TELOPEA CONCEPT PLAN AND STAGE 1A

Submissions Report
SSD-14378717

Prepared for
FRASERS PROPERTY TELOPEA DEVELOPER PTY LTD
20 April 2022

Figure 1 Upper Core Skyline

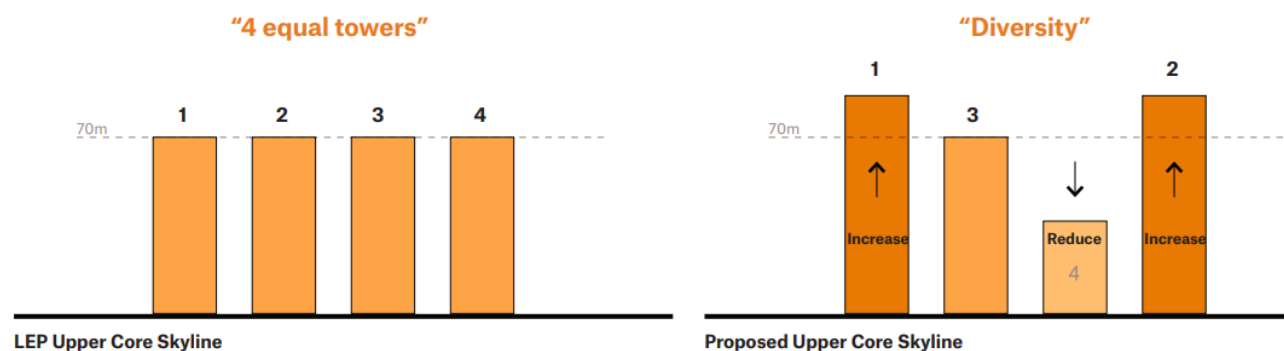
Based on the LEP height control and Telopea Masterplan, a compliant scheme would allow for four 70 metre towers located within the Core Precinct at the top of the hill (refer to **Figure 1**). The proposal revises the proportions of three of the four upper core buildings to provide a diversity in tower form skyline variation.

The proposal reduces the number of tall buildings (above 70 metres) in the upper core from four to three. Two towers have increased in height by 5 storeys compared to an LEP compliant scheme, to enable one of the tower forms to reduce in height by half, introducing a new street wall mid-rise typology into the upper core, illustrated in **Figure 5**. Key changes include:

Figure 6 Refinements to open space in Stage 1A

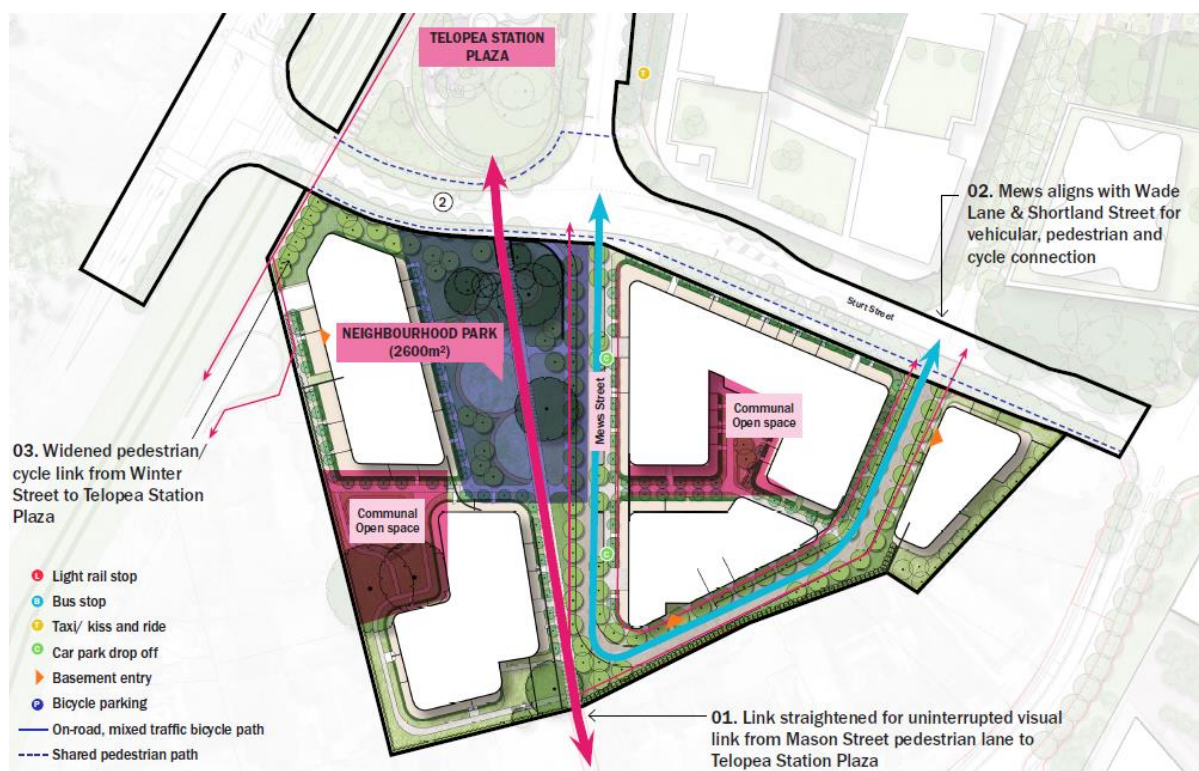
In response to submissions from Council, TfNSW and the public, the proposed basement entrance for Stage 1A has been moved from Winter Street with all traffic and parking now directed along Sturt Street. The additional amendments have resulted in reconfiguration of open space to improve north-south link legibility and update the configuration of both public open space and communal open space as illustrated in **Figure 6**.

Figure 11 Upper Core Precinct Elevations

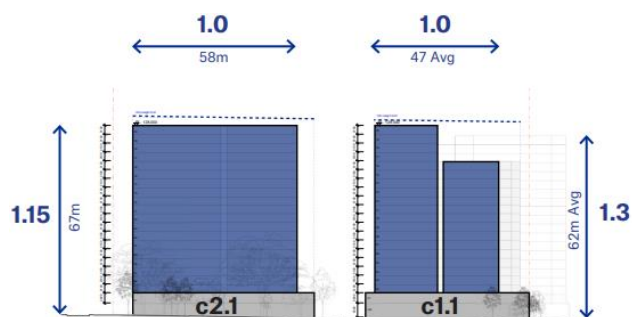
An LEP compliant scheme would result in six large footprint towers in the upper core, all of which would have typical floorplates larger than 1000sqm. The proposed envelopes envisage reduced tower footprints that are further setback from the public domain. Significantly, three of the tower forms that were above 1,000sqm have been reduced to less than 1,000sqm, with one tower (C2.2) reducing in height significantly, introducing a new mid-rise street wall typology into the upper core.

Overall, the refinements to the bulk and scale within the Core Precinct have improved solar access to the public domain including Eyles Link, the retail courtyard, the library interface and community courtyard. Refining the envelopes and reducing height in key areas has improved the available daylight, maximises the potential for tree retention and adjacent landscape areas.
